**Approved baseline and monitoring methodology /
methodological tool clarification response form
(Version 03.0)**

Date and number of Panel / WG meeting:	20-24 Sep 2021 / MP 86
Title/Subject of the request for clarification:	The application of the Approved Methodology AM0009 for the Project implemented at the Gas Condensate Field
Reference number of the request for clarification:	AM_CLA_0294
Exact reference (number, title and version) of the methodology or methodological tool to which the request for clarification applies:	AM0009: Recovery and utilization of gas from oil fields that would otherwise be flared or vented --- Version 7.0
Fast track or Regular track:	<input type="checkbox"/> Fast track <input checked="" type="checkbox"/> Regular track

AM0009: Recovery and utilization of gas from oil fields that would otherwise be flared or vented --- Version 7.0

Figure 1. The Crude Oil Treatment Scheme

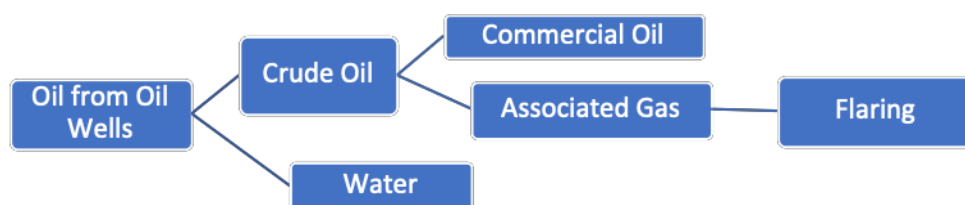
Oil and gas condensate treatment technologies can be also considered as identical. Separation is used in gas and oil production facilities in gas and oil fields, resulting in the formation of unstable gas condensate (crude oil). Unstable gas condensate is characterized by saturation with light hydrocarbon fractions and, in some fields, with hydrogen sulfide compounds or carbon dioxide. The transportation of such a product is not recommended, since when the pressure decreases, a gas phase is released, which restricts the movement of the liquid.

The methodology cannot be applied to gas condensate fields as it currently stands because it applies to projects that recover and utilize the associated gas and/or gas-lift gas from oil fields only (i.e. crude oil being the main product, and associated gas as a by-product), and in the baseline situation, the associated gas would have been vented or flared. The proposed revision could involve the recovery and utilization of non-associated gases such as natural gas, dry gas, LPG, condensate, etc. Although the request refers to “gas condensate field”, the distinction of such fields from a natural gas field is not explicit from the proposal.

Figure 2. Light liquid hydrocarbons e.g. Gas Condensate Treatment Scheme

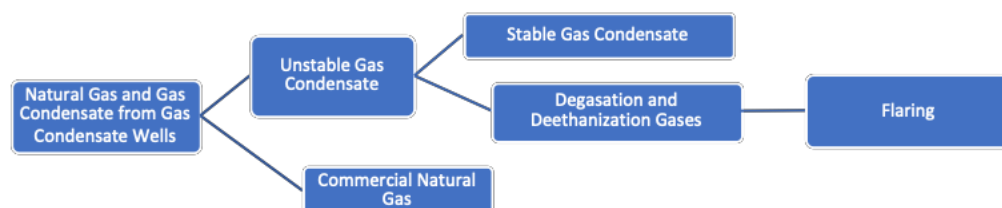
Hydrocarbon condensates must be stabilized before further processing, and when processing sulfur condensate - and hydrogen sulfide also. The essence of oil stabilization is to separate volatile hydrocarbons (propane-butane fraction) from it, as well as associated gases soluble in oil, such as hydrogen sulfide, carbon dioxide and nitrogen. This process leads to the reduction of the oil losses from evaporation, reduces the intensity of the corrosion process of the facilities, equipment and pipelines along the path of oil movement from the field to the refinery, and also allows obtaining valuable raw materials for petrochemicals. A wide fraction of hydrocarbons is obtained by the oil and gas condensate stabilization starting from CH₄ up to C₇H₁₆, depending on the stabilization method and the properties of the raw material.
